# **Tualatin Subbasin**

**TOTAL MAXIMUM DAILY LOAD (TMDL)  
& WATER QUALITY MANAGEMENT PLAN (WQMP)**

## **Response to Public Comment**

*Prepared by:  
Oregon Department of Environmental Quality  
January 31, 2001*

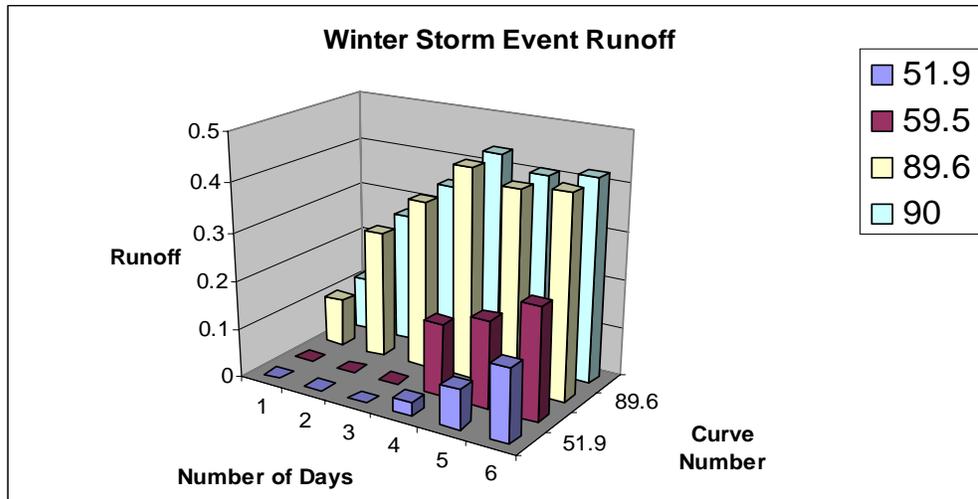
**Comment B25. The reasoning for choosing the winter design storm needs to be clarified.**

**Response:** Using daily precipitation data as recorded at the Beaverton gage (period of record 1972-1999) DEQ calculated the cumulative precipitation volumes for storms of 1 - 6 days in length. A frequency analysis was conducted on the values recorded for each storm length. The runoff was calculated for each of the 90<sup>th</sup> percentile precipitation values, by the following equation:

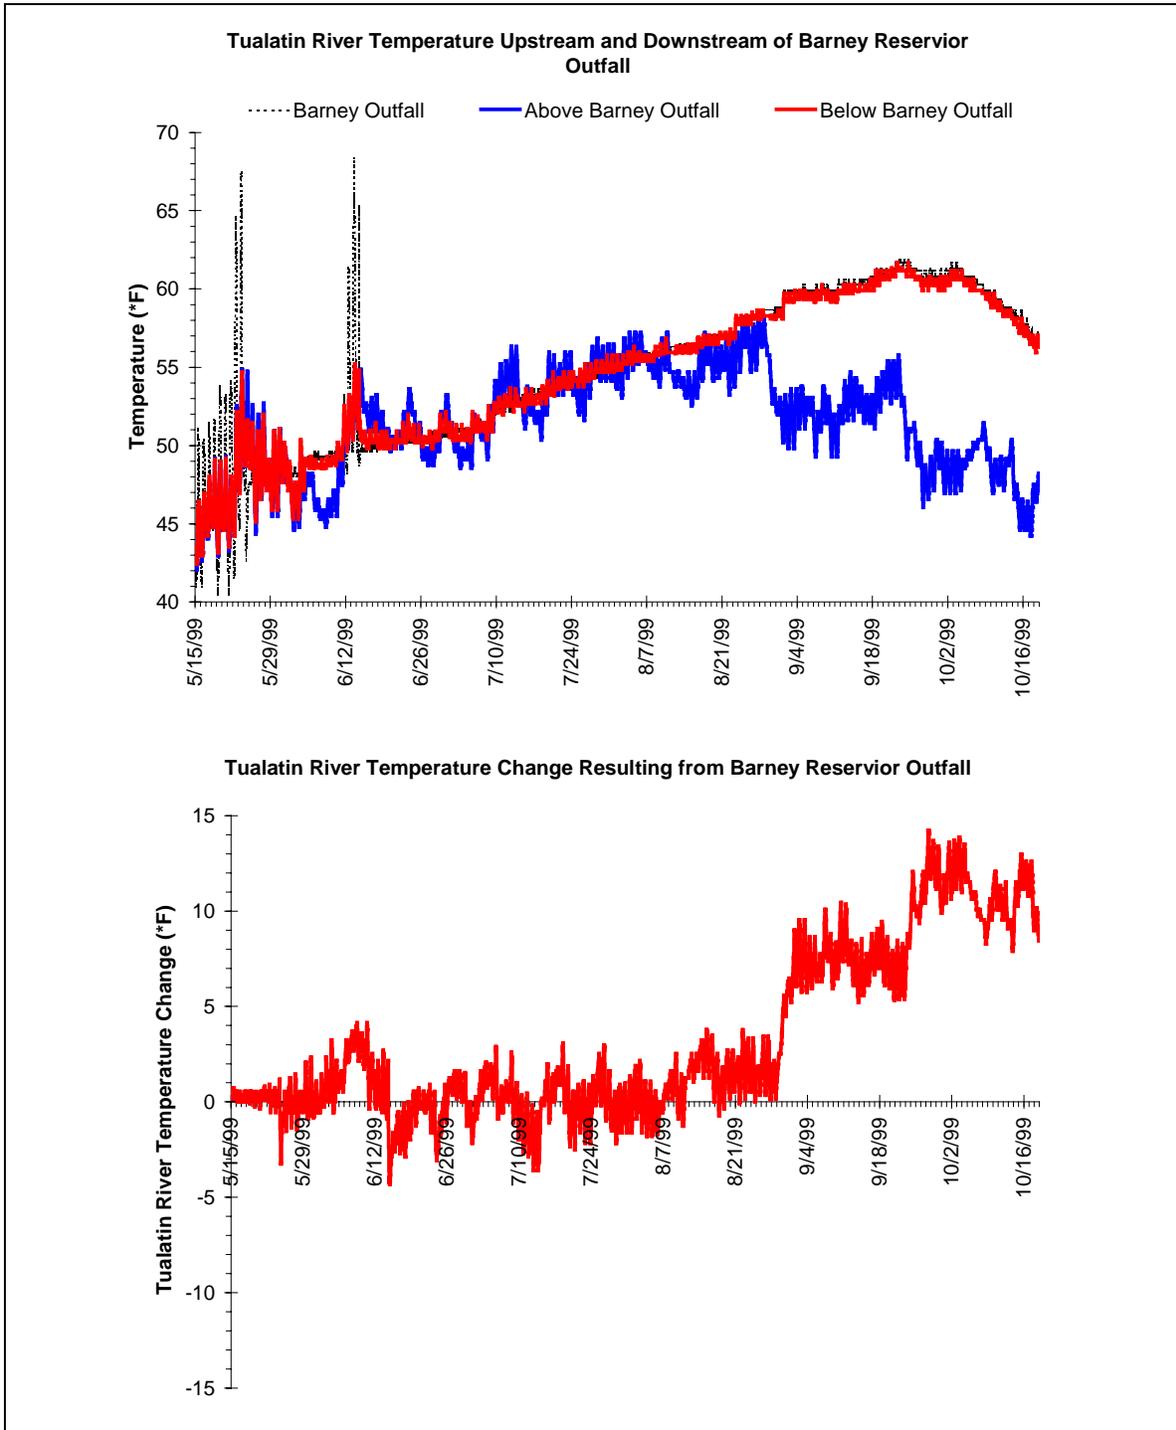
**Comment T9. The Barney Reservoir releases should be examined for impacts.**

The Barney Reservoir releases flows to the Tualatin River near the headwaters (at river mile 82). Data collected in 1999 demonstrate that the influence of Barney Reservoir releases on the Tualatin River vary throughout the year. Reservoir release thermal impacts are listed below.

Effective Shade Sensitivity to Vegetation Density (ODEQ Simulations)

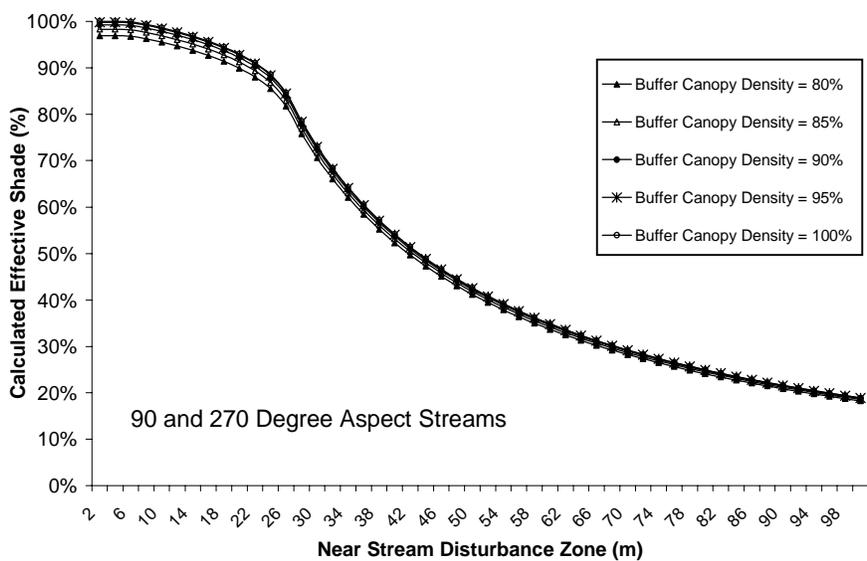
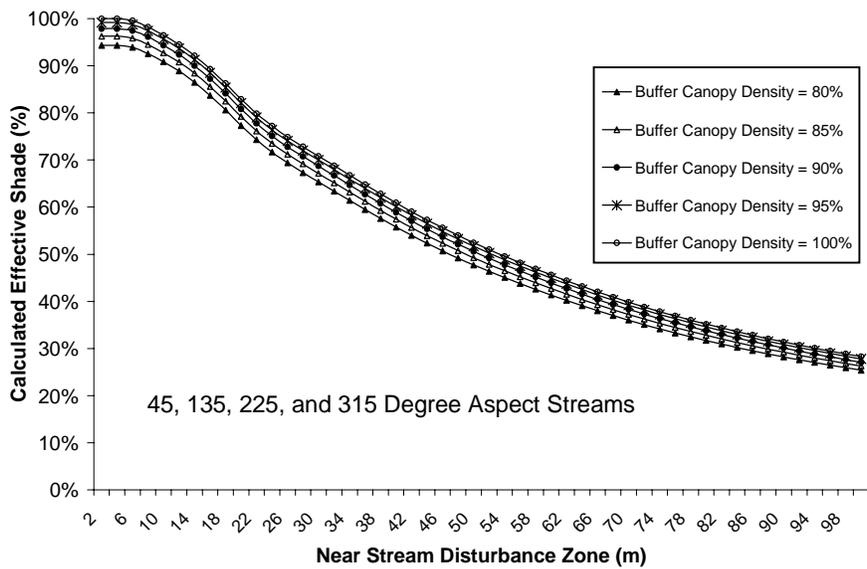
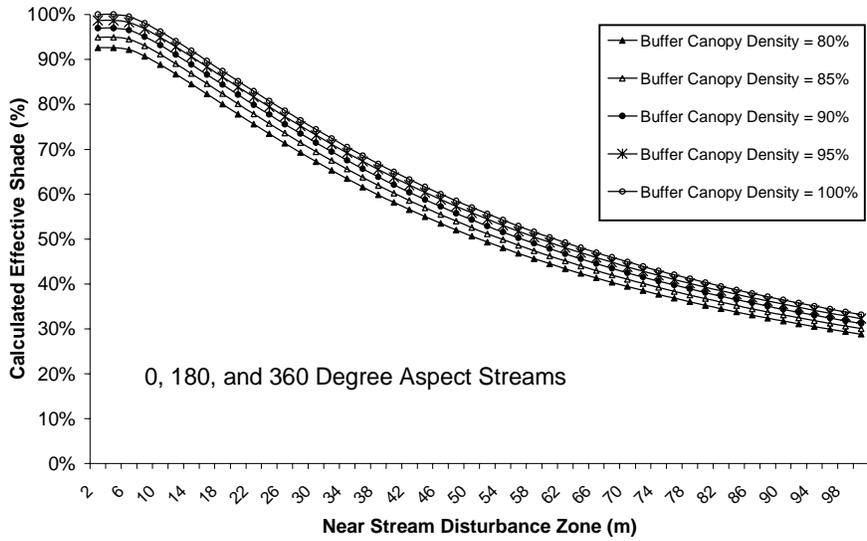
**Comment T19. “Is the “potential mature vegetation” density of 90% inferred from field data or selected arbitrarily, also what is the sensitivity of the temperature modeling to changes in this value. ”**

The charts below illustrate the sensitivity of effective shade calculations to buffer canopy density conditions (termed vegetation density within the TMDL) within the Tualatin River subbasin. As can be seen, effective shade levels have little sensitivity to vegetation density when values are between 80% to 100%.

Data used in the sensitivity analysis were: tree height = 110', overhang = 5', elevation = 328', date of simulation is 7/27/99.

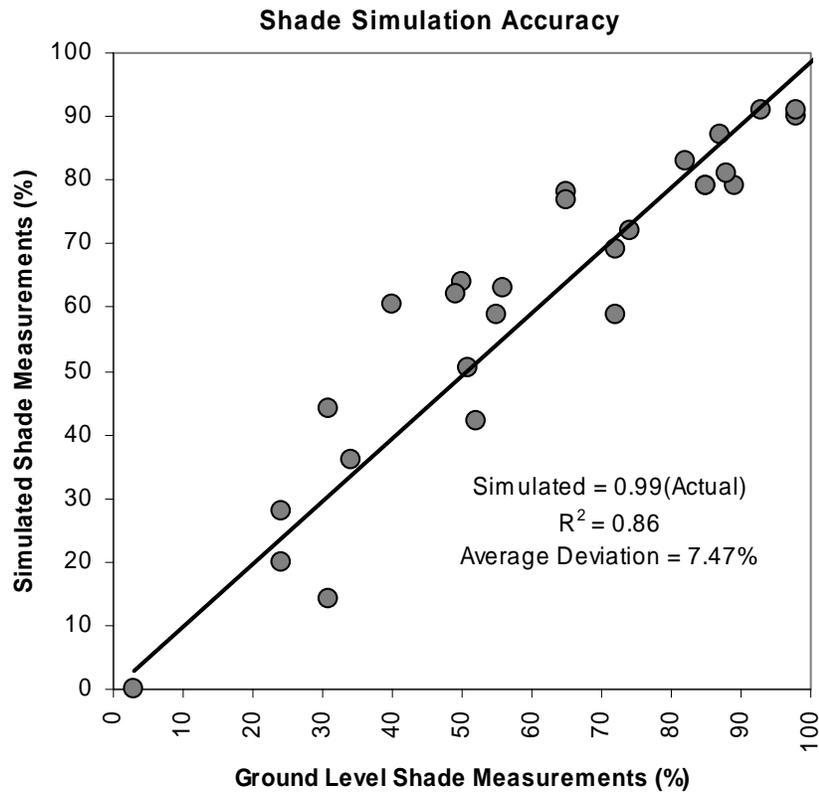
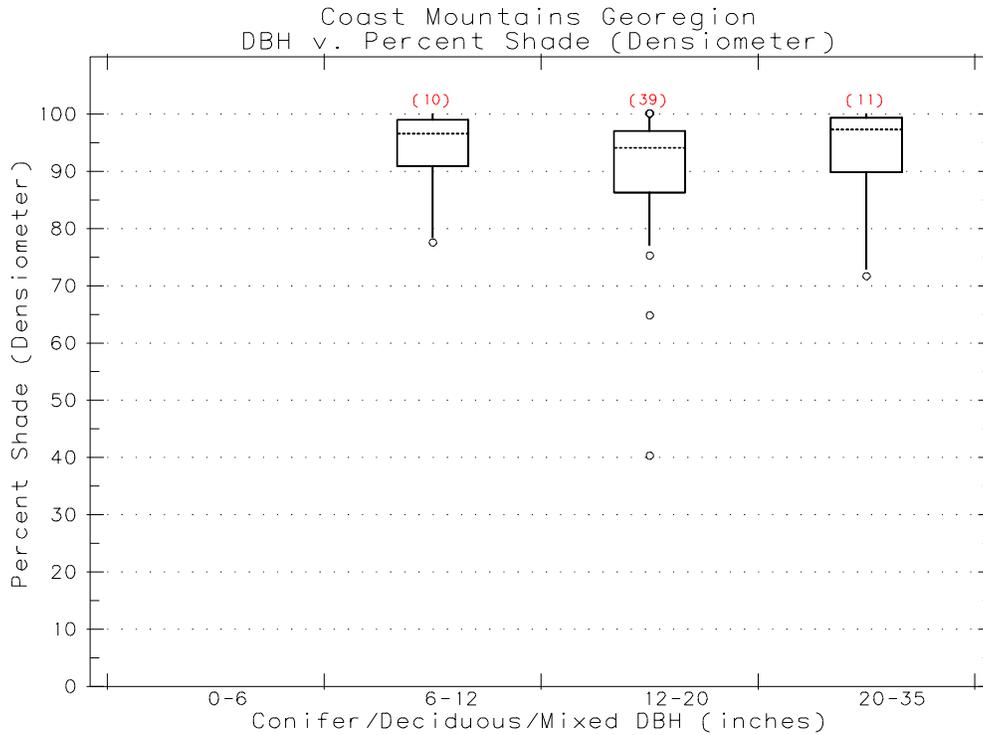
**Comment T20.** “It would add significantly more credibility to the process if ground-based data were presented to evaluate the validity of the “shade calculator”, especially in light of the fact that the predicted relationship between shade and stand age is inconsistent with the relationship observed in the ODFW stream surveys (see ODF comments to DEQ on the UGR TMDL, 3/13/00).”

As part of this TMDL data collection effort, effective shade was measured at numerous locations throughout the subbasin. A close correlation between observed shade conditions and simulated shade conditions exists ( $R^2 = 0.86$ ). Ground level effective shade measurements are an average of several “point” measurements with a sampling rate of approximately 100 feet. The department considers the methodology and results credible, given the accuracy of the of effective shade simulations.

ODF asserts that the stand age and effective shade can be inversely related. ODF uses tree diameter breast height (dbh) as a surrogate for stand age. An Oregon State University document prepared for ODF (Cumulative Effects of Forest Practices in Oregon: Literature and Synthesis 1995) states that the angular canopy density (%) is proportional to stand age (Figure 7.22, page 61).

To evaluate this relationship ODEQ summarized ODF data collected with the intent of quantifying the relationship between stand characteristics and stream surface shade (1999 ODF Shade Study). Data from this effort does not support the assumption that increased stand age (assuming dbh is a surrogate to stand age) correlates to lower shade levels. Tree diameter and effective shade data presented in the figure below indicate that shade levels remain statistically unchanged as a function of tree size (ranging 6 to 36 inches).

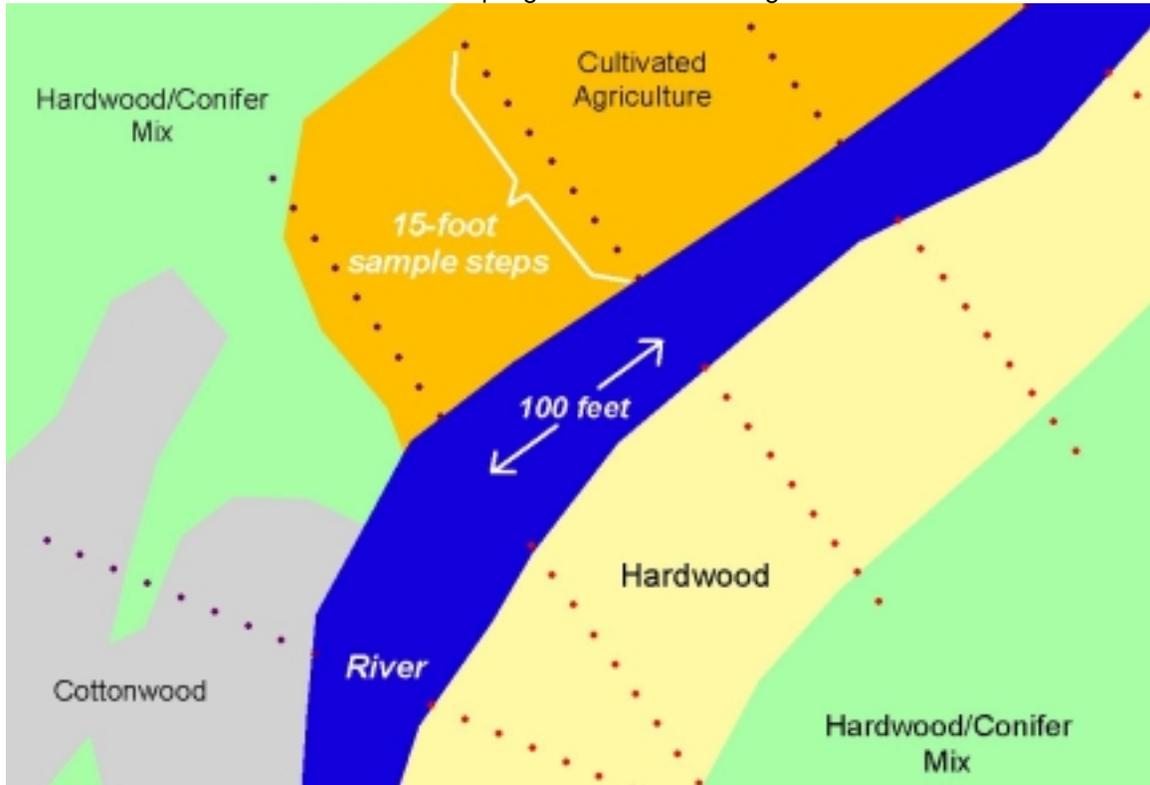
**Comment T21. “Given that the achievement of “system potential” as defined in the this TMDL will result in neither maximum shade nor a condition that emulates pre-European settlement, how does the achievement of the TMDL protect and restore the fish populations that water quality standards are designed to address?”**

The Tualatin River Subbasin TMDL is not designed to emulate pre-European settlement conditions. The TMDL does not target the "maximum shade." The TMDL simply estimates near stream vegetation types and characteristics that are expected to be present in the absence of anthropogenic disturbance. Instead of selecting vegetation types based on the ability to shade a stream, the TMDL selects vegetation types that are appropriate to the ecoregions in the Tualatin Subbasin.

The Tualatin River Subbasin temperature TMDL is designed to eliminate heating due to anthropogenic activities and is consistent with the temperature standard. By targeting the temperature standard, beneficial uses are protected (i.e. standards are designed to protect sensitive beneficial uses). The Department believes that the application of the temperature standard within the Tualatin River subbasin will protect and restore the fish populations (i.e., sensitive beneficial uses).

It should be noted that the TMDL does not prohibit the management for "maximum shade." Individuals and land managers can choose to exceed effective shade surrogate measures.

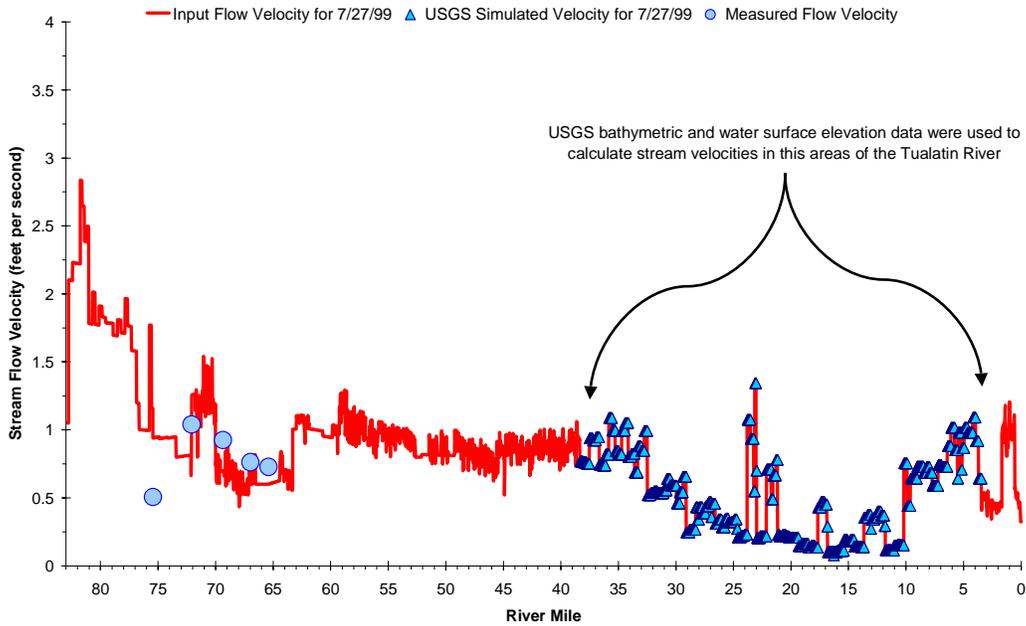
**Comment T30. Widths graphed in figure A-41 do not always correlate with USGS cross-sectional data.**

Channel widths were digitized from digital orthophoto quads with a 1-meter pixel resolution at a 1:5,000 resolution. There may be a level of error introduced in the digitizing process. These channel widths were then sampled using a ODEQ GIS tool. No inaccuracy is introduced during the sampling process. ODEQ cannot explain some of the differences observed between ODEQ and USGS channel width data.

### Tualatin River Average Wetted Depth (7/27/99)

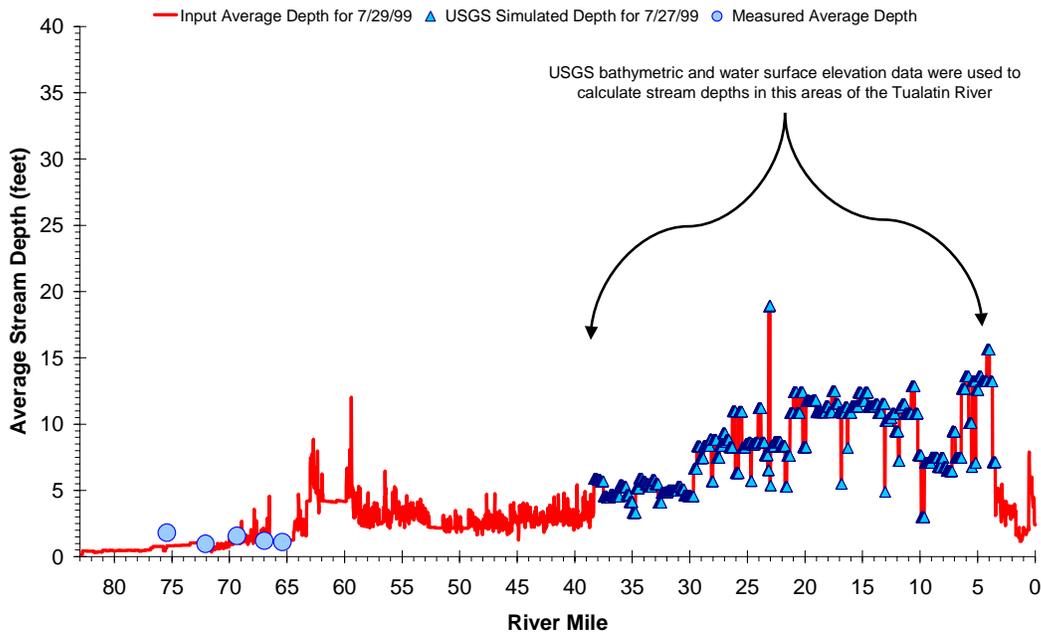
**Comment T31. The velocities and mean depths used in the temperature model for the reservoir reach are not accurate.**

The Department has made the following changes to the temperature model.
